Replacement of T2291 with T2930

Pagid aims to streamline the designation of T2291 to T2930.

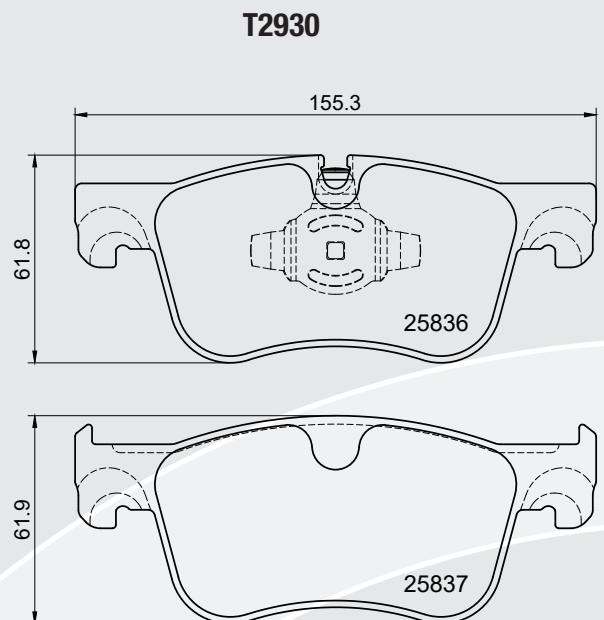
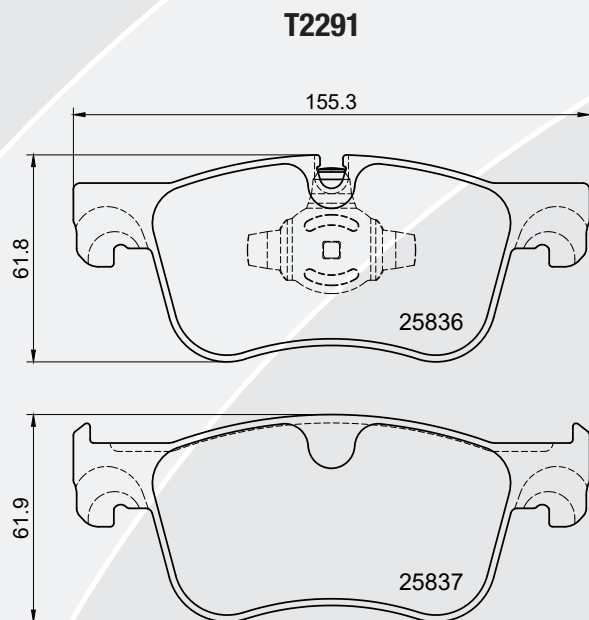
The difference between T2930 and T2291 is the T2930 thickness is slightly thinner, the chamfers will be modified from parallel to segment, and a foil cover will be applied to 25837 WVAs.
